MEETING NOTICE AND AGENDA
TECHNICAL ADVISORY COMMITTEE
OF THE
SEASIDE BASIN WATER MASTER

DATE: Wednesday, March 11, 2015

| <u>Agenda Item</u> | <u>Page No.</u> |
|---|-----------------|
| 3. Peer Review of HydroMetrics Laguna Seca Subarea Modeling Work | |
| A. Presentation of Draft Peer Review Technical Memorandum (Gus Yates) | 6 |

| March 2015 | Figure 5 Annual Northern Coastal Layer 5 Inflows and Outflows, 1987-2013 |

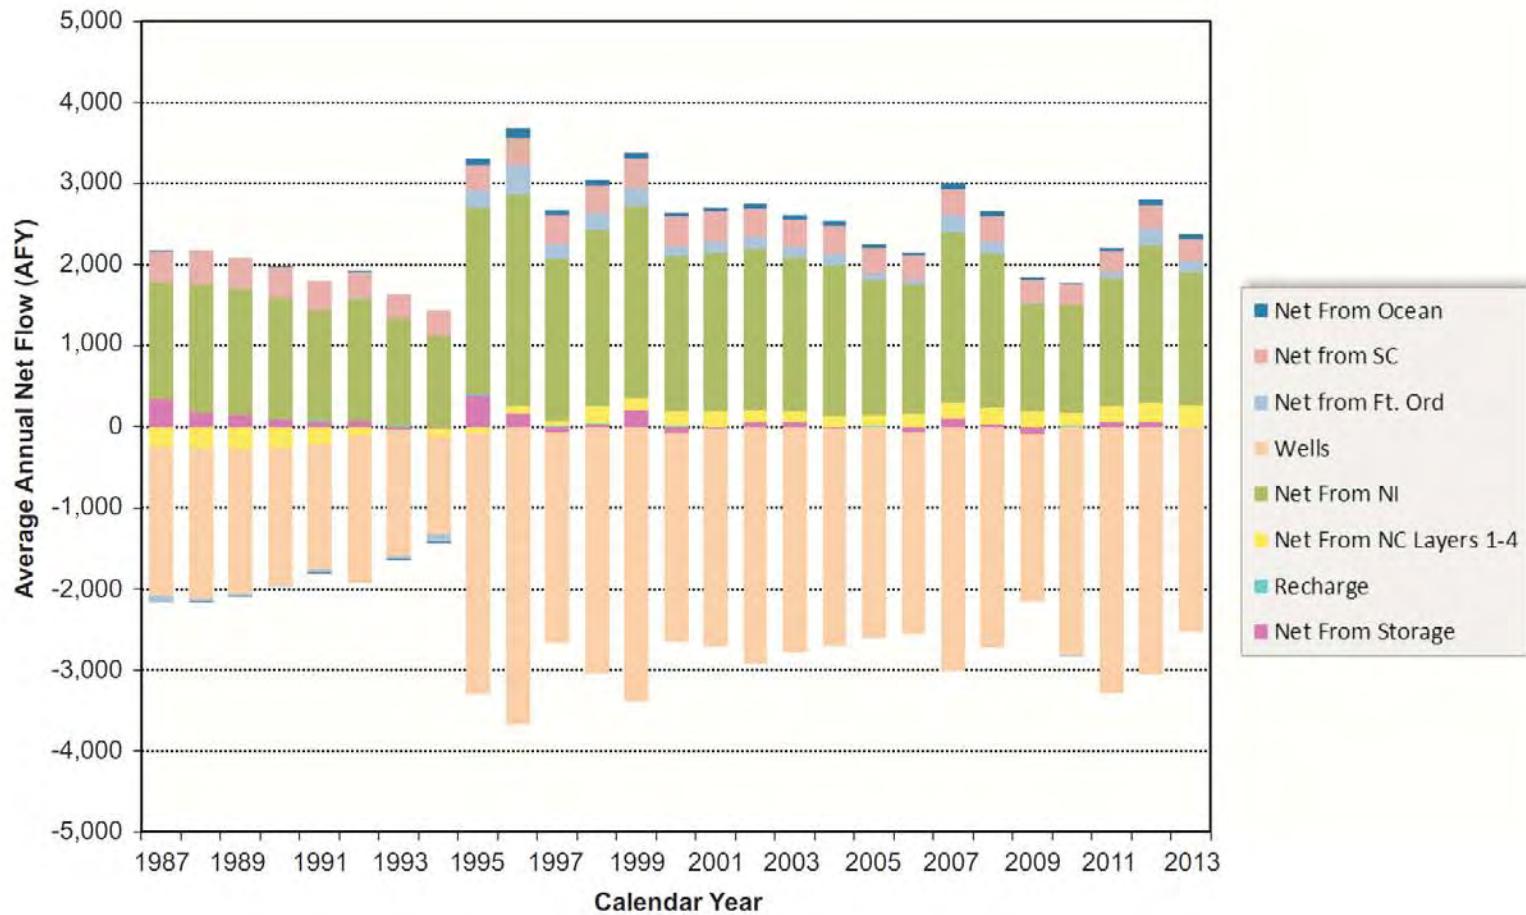
A possible explanation for the discrepancy is that formation of a pumping trough (local storage depletion) is prevented by too much simulated groundwater inflow. In addition to the storage response, the Santa Margarita aquifer in the Northern Coastal Subarea has five other head-dependent flow boundaries: net inflows from the Northern Inland Subarea, Fort

Ord, the ocean, the Southern Coastal Subarea, and the overlying Paso Robles aquifer. Simulated annual net inflows across each boundary during 1987-2013 are shown in **Figure 5**. Each of those boundary flows will respond to a change in pumping. The sensitivity tests described below were designed to test the relative magnitudes of the boundary responses to determine whether one or more of them was primarily responsible for preventing the development of a pumping trough.

| March 2015 | Figure 6 Annual Laguna Seca Inflows and Outflows, 1987-2013 |

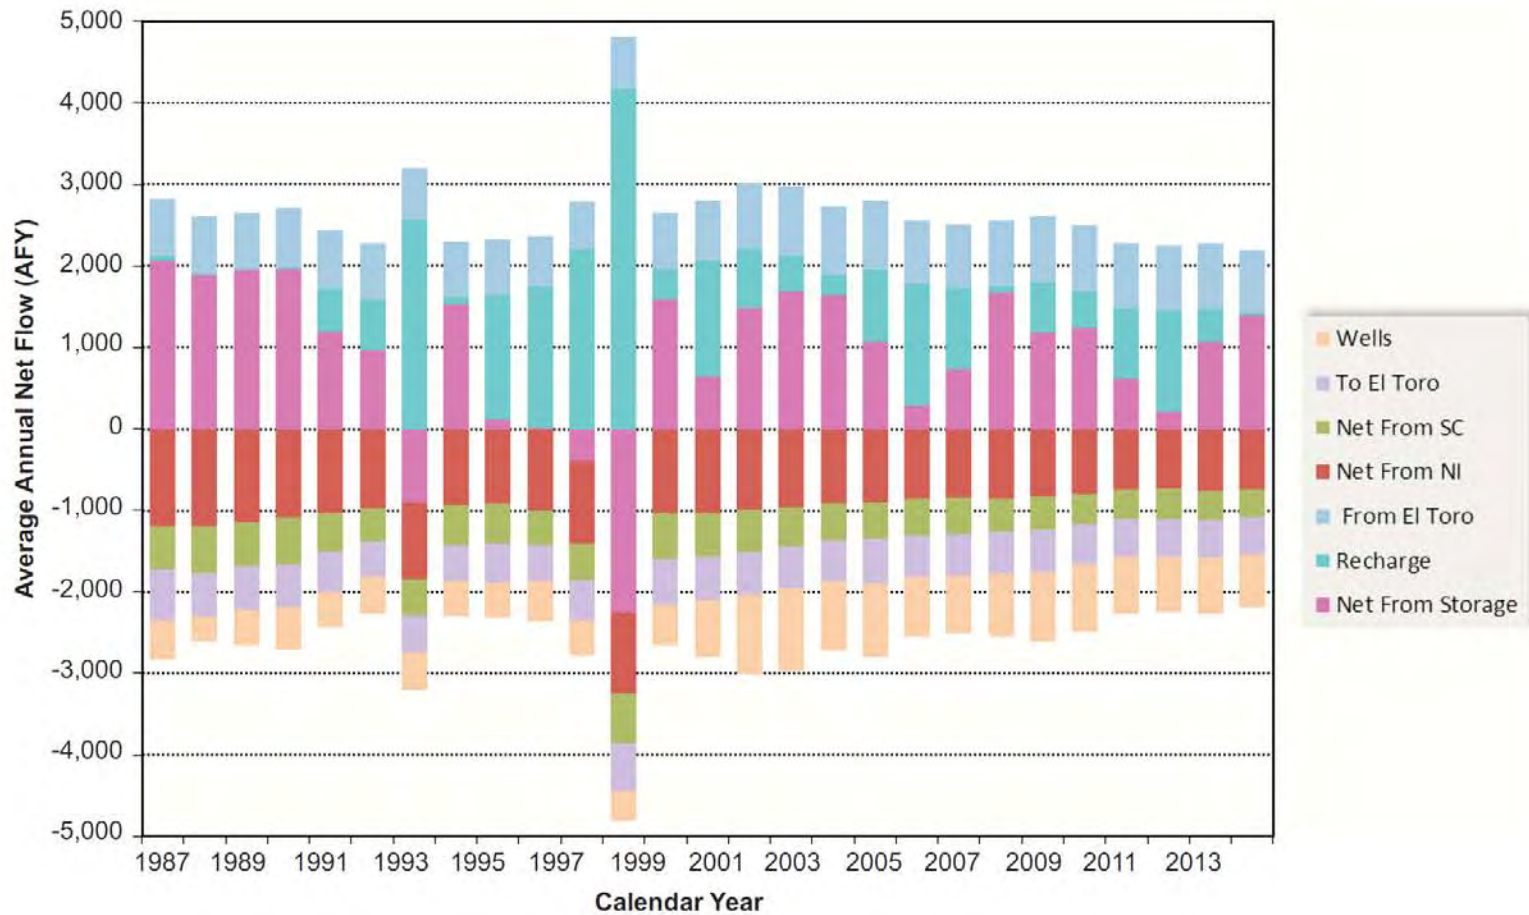
Head-dependent flows in the Laguna Seca Subarea water balance are storage change, net inflow from the El Toro Subarea, net outflow to the Northern Inland Subarea and net outflow to the Southern Coastal Subarea. **Figure 6** shows annual inflows and outflows for the Laguna Seca Subarea in the groundwater model during 1995-2013. Inflows from El Toro and outflows to El Toro are both fairly large in the groundwater model, whereas the flow is almost exclusively outflow at the other two boundaries. For clarity El Toro inflows and outflows are shown separately in the graph. Recharge is also shown to put the magnitudes of the other inflows into context.
